## Circular No. (3)

**Reference: SEZAD Tender No. (19-2015) "EPC Construction Services for Detailed Design and Construction of the Duqm Refinery Service Corridor to the Liquid Jetty"**

### Subject: Reply to Queries

SLEEPER - TIE BEAM LAYOUT PLAN - Part 29  
SCALE 1:300

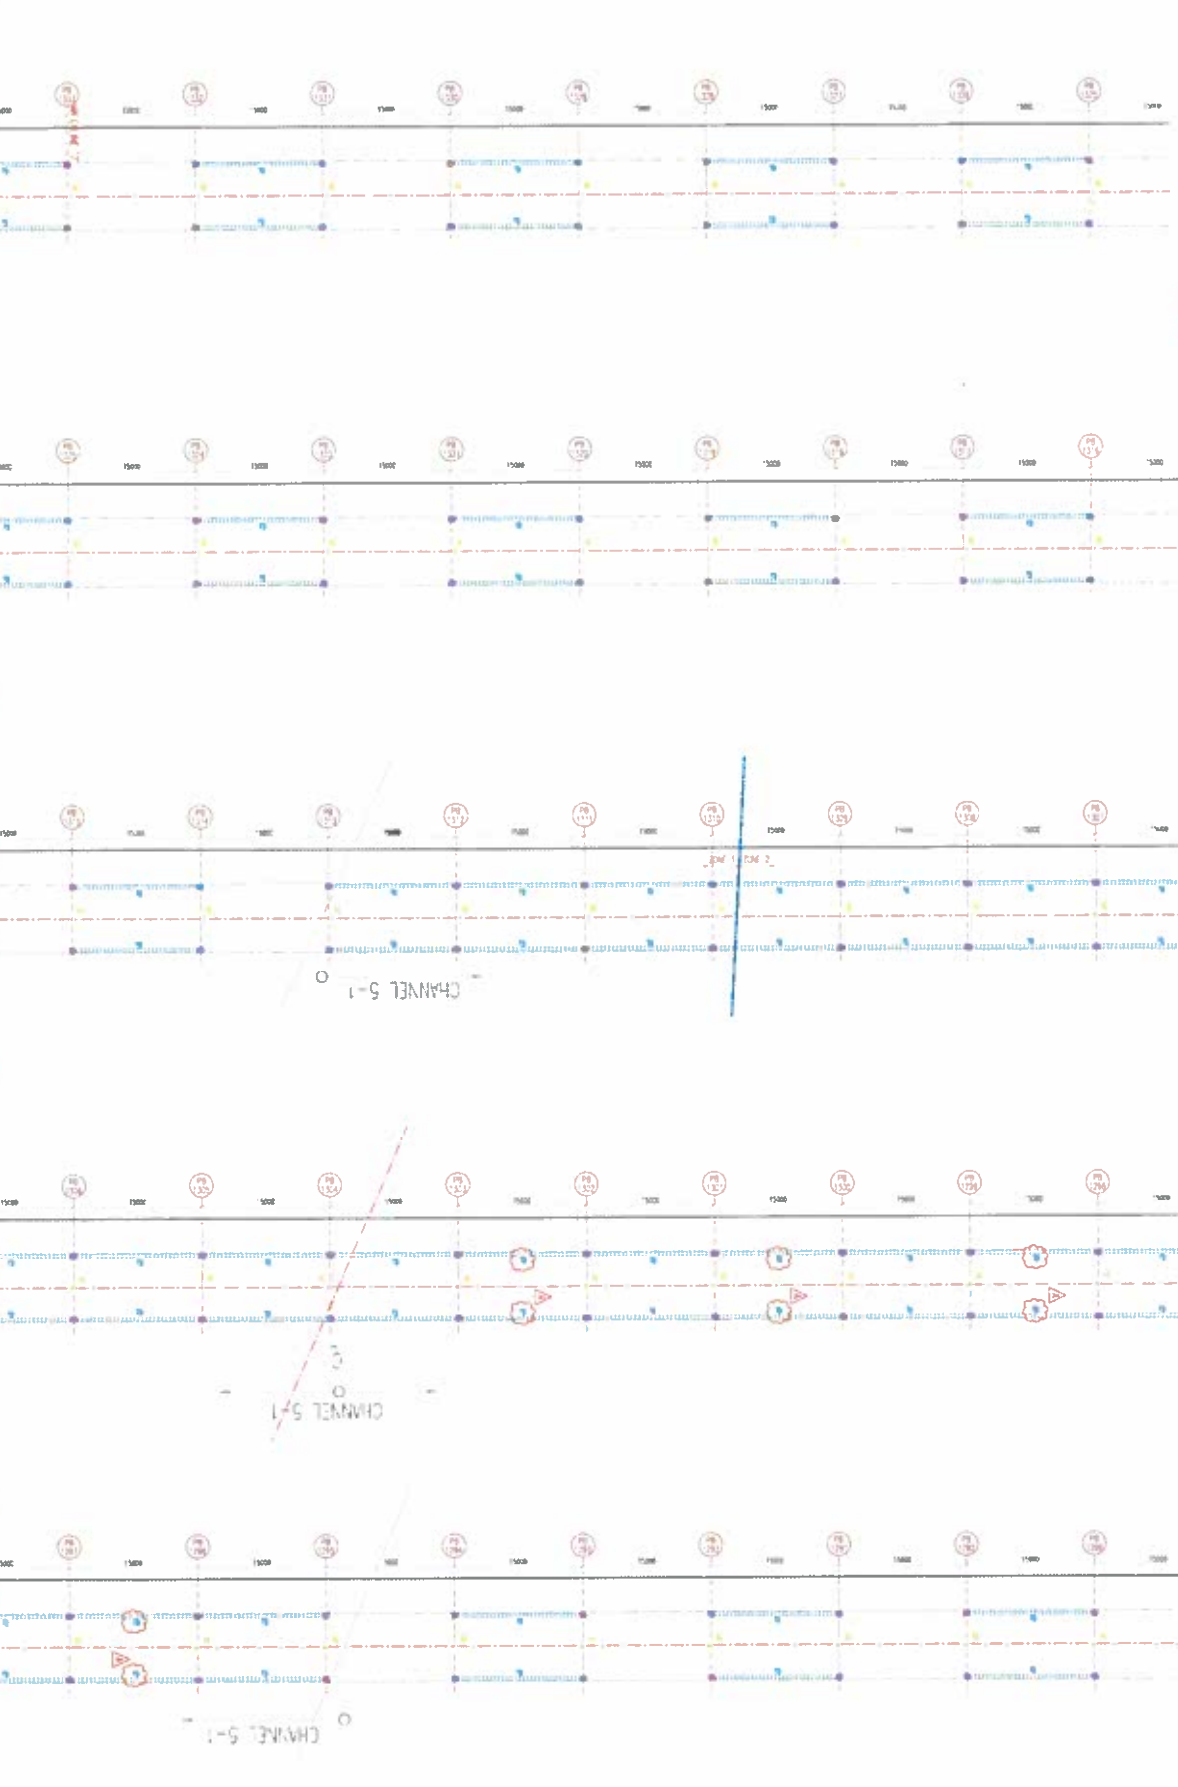
10.	Drawing 1409/DUQM/120/SE indicates a hit /miss arrangement for the tie beams across part of the Channel 5-1 (PB 1295 to PB 1303). Please confirm if this is correct or is it a design error and the tie beams should be continuous as per the bridge over Wadi Saay.		The tie beams should be continuous throughout, as per the stretch from PB1313 to PB1304. Hence, there should be an additional 8 (=4x2) nos. of tie beams. Please refer to amended drawing 1409/DUQM/120/SE/A. provided with this circular.
